ACCC PUBLIC FORUM

Transmission Revenue Cap 2003 – 2007/08

4 October 2002

TransÉnergie Australia Pty Ltd

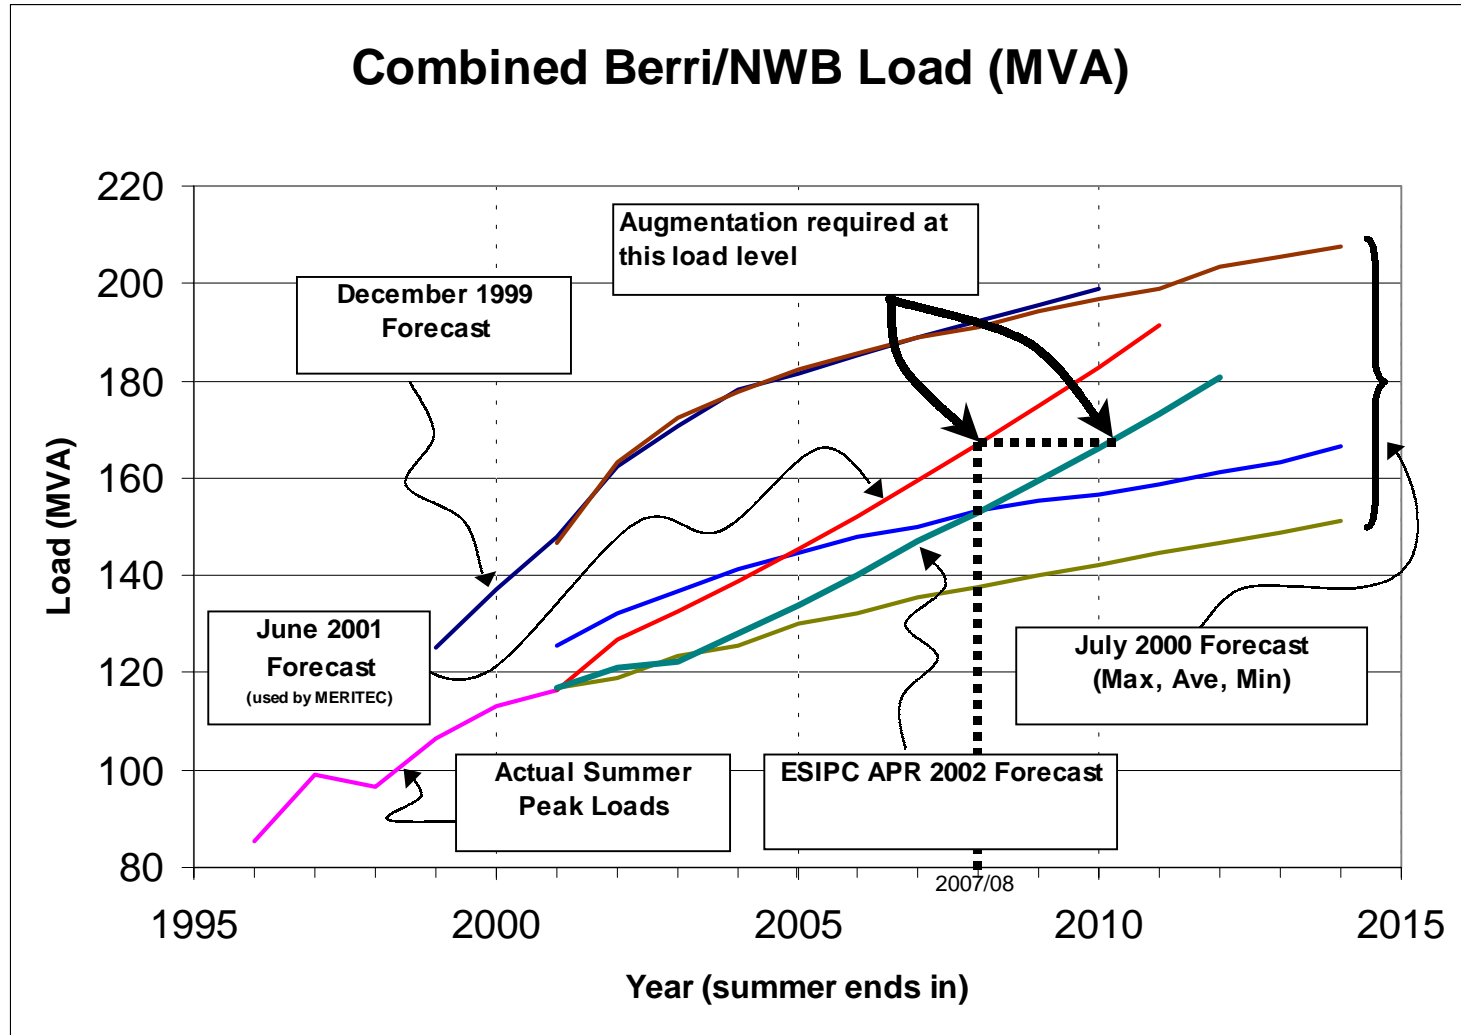
- TEA does not agree that a new transmission line is required to provide the necessary support to the Riverland. Earlier Meritec and ESIPC studies concluded that:
 - **Murraylink (through a network support agreement) in combination with the existing network can provide the necessary support to the Riverland region.**
- ESIPC has confirmed that Murraylink has sufficient power transfer capability to resolve the limitations until approximately 2007/08 and has therefore recommended:

“a Riverland support facility is required to operate in conjunction with Murraylink in order to fully meet requirements.”

- Meritec's studies concluded Murraylink could provide the necessary support until 2007/08, but incorrectly assumed it would be unable to enhance the network's capacity to meet voltage requirements after this time.
- TransÉnergie believes Murraylink can in fact provide the necessary support for an additional 5 years – until 2012/13 because:
 - More recent load forecasts show lower load growth in the Riverland, and
 - Relatively low cost capital expenditure on shunt capacitors could defer the need to construct a new transmission line.
